EAI 125 - Building 3 – Unit 3B – Supply & Kitchen Make-Up

EAI 125 - Building 3 – Unit 3B – General Extract

EAI 125 - Building 3 – Unit 3B – Kitchen Extract

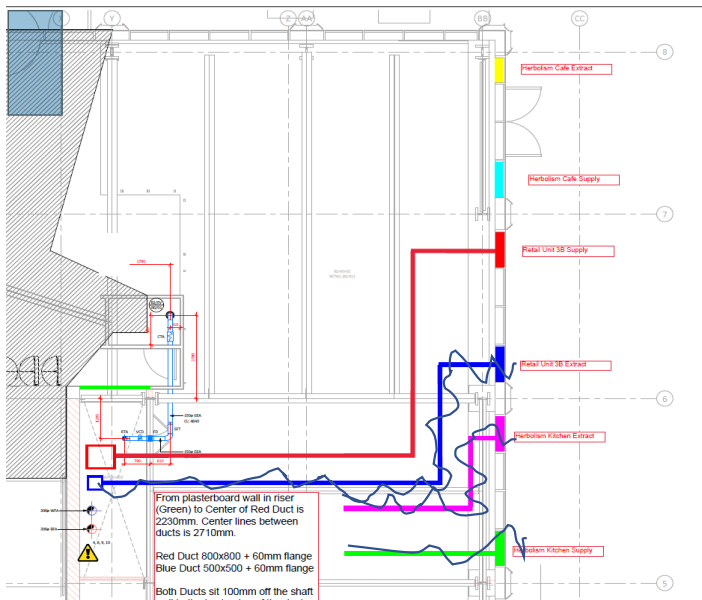
- Queries:-
- Based on a PL-5700 Louvre type a pressure drop of 18.30Pa is calculated. This is to be verified with Bruntwood.
 - Proximity to the Final Escape door (DE.B2.00.05) has been reviewed by DFC and confirmed acceptable.

- Notes:-
- Distance between adjacent extract and supply in excess of 2M as advised by CIBSE, therefore OK.
 - It will not be possible to accommodate the future Herbalism requirements as previously planned (slide 6) and an alternative configuration will be required, potentially like slide 7.

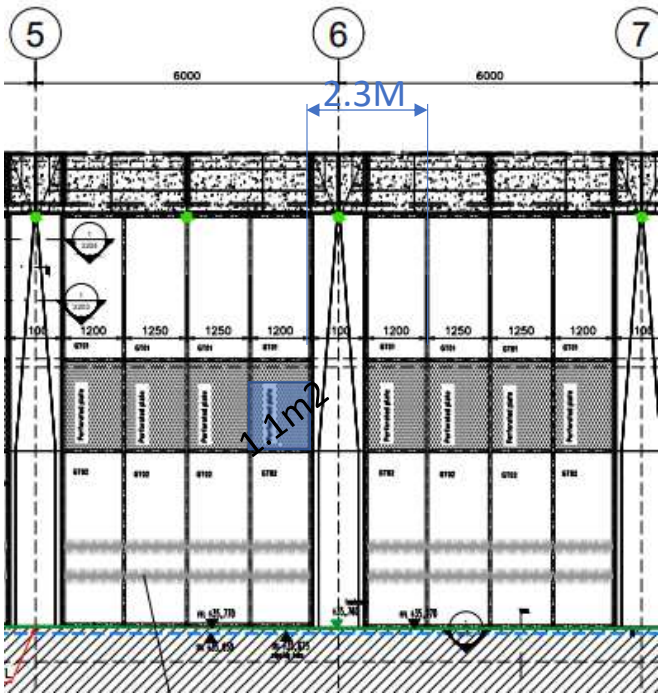
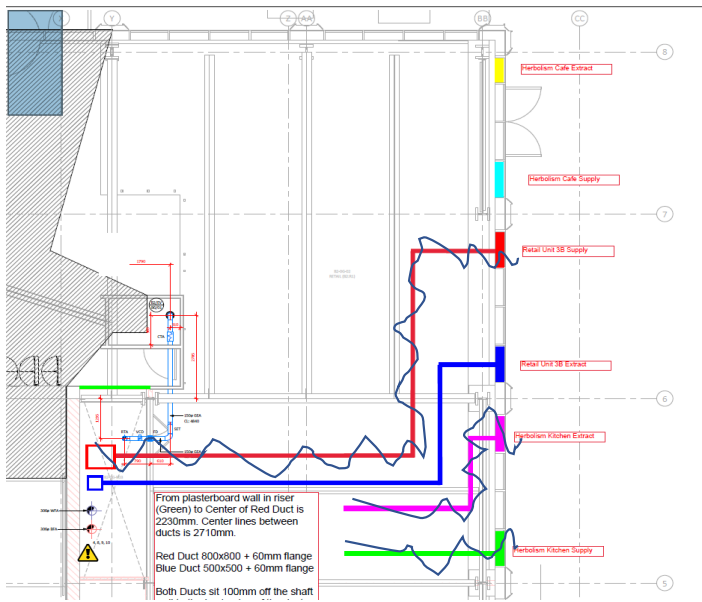
- Queries:-
- Based on a PL-5700 Louvre type a pressure drop of 16.9Pa is calculated. This is to be verified with Bruntwood.

- Notes:-
- Distance between adjacent extract and supply in excess of 2M as advised by CIBSE, therefore OK.
 - It will not be possible to accommodate the future Herbalism requirements as previously planned (slide 6) and an alternative configuration will be required, potentially like slide 7.

Herbalism Future Requirements:- Original Proposal

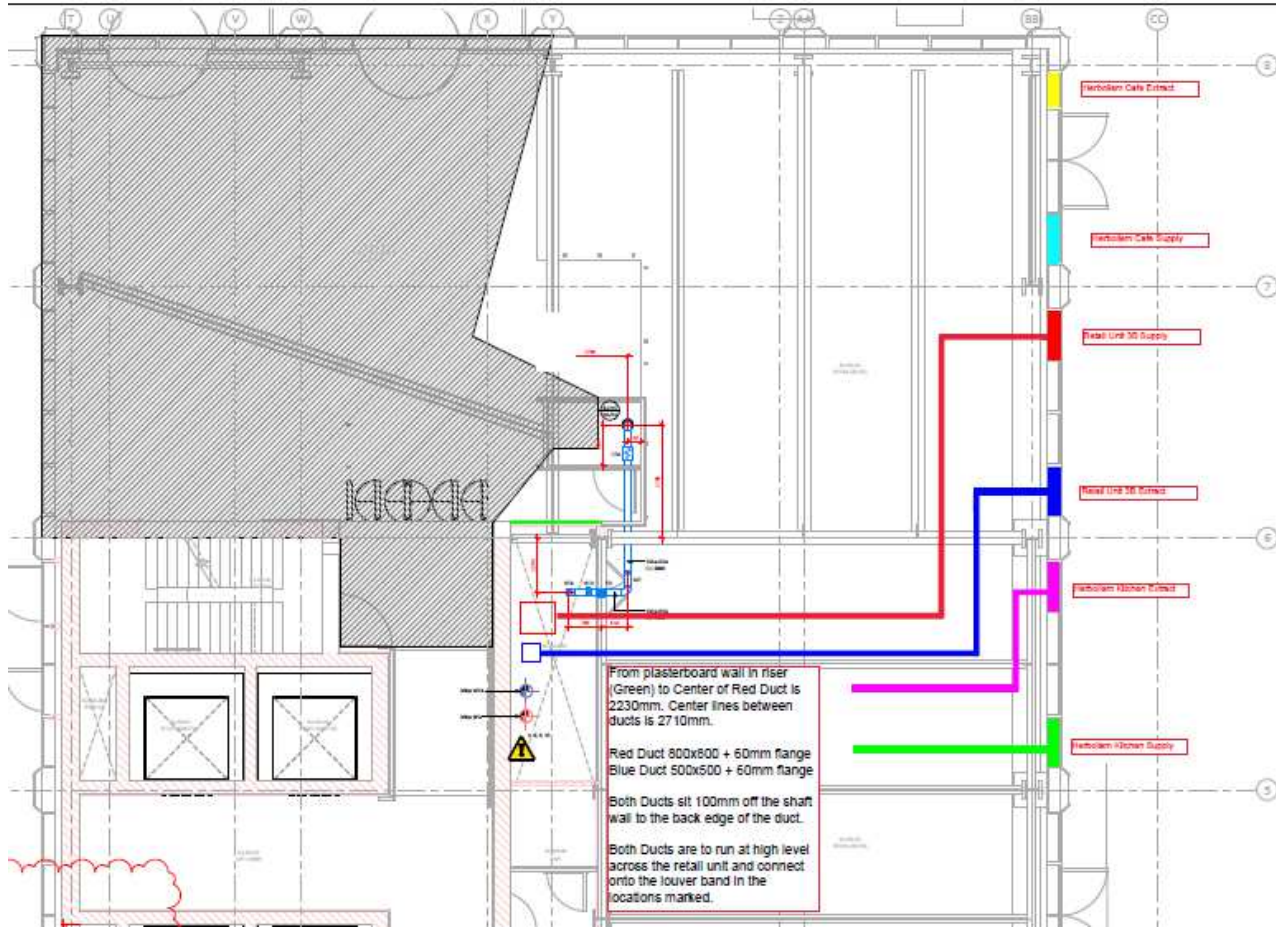
- For EAI 125 the louvre sizes are currently sized on the noted Pa values (slides 4, 5 & 8). If these values are not acceptable by Bruntwood the louvre sizes will need to change.
- Based on the current proposal, we cannot accommodate the future Herbalism requirements as previously drawn opposite.

From plasterboard wall in riser (Green) to Center of Red Duct is 2230mm. Center lines between ducts is 2710mm.

Red Duct 800x800 + 60mm flange
Blue Duct 500x500 + 60mm flange

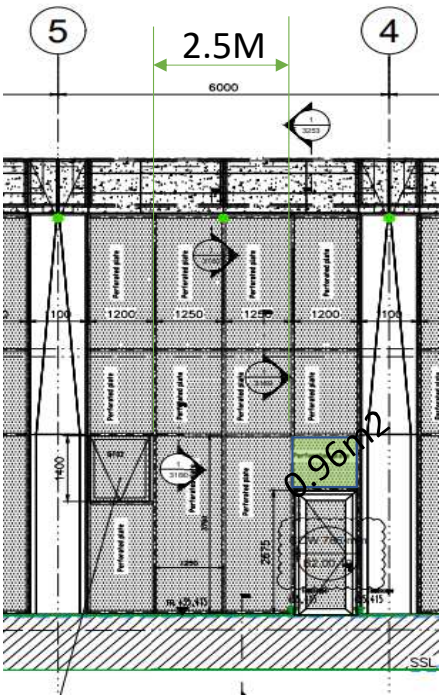
- Queries:-
- The current louvre extent is restricted due to the BWIC allowances to the shear wall behind.
 - Based on The PL-5700 louvre type a pressure drop of 49Pa would be achieve with air speed / velocity of 2.5m/s.
 - An alternative type PL-5605 Louvre would achieve a 25.85Pa Pressure drop with air speed / velocity of 2.5m/s.
 - Our preference would be to use the PL-5700 louvre type, but both values would need to be checked with Bruntwood as to which is acceptable.
 - Proximity to the MOE and AOV has been reviewed by DFC and confirmed acceptable.

* Please note the current BWIC as Curtin’s sketch ref:- MA1420-SK20072202 (Rev P02) is required to be amended to align with the louvre location as indicated below. In principal the BWIC needs to be extended higher to allow a duct connection to the rear of the louvre at the same height, currently the BWIC detailed is too low. This has been discussed with Curtin’s and is feasible to achieve.
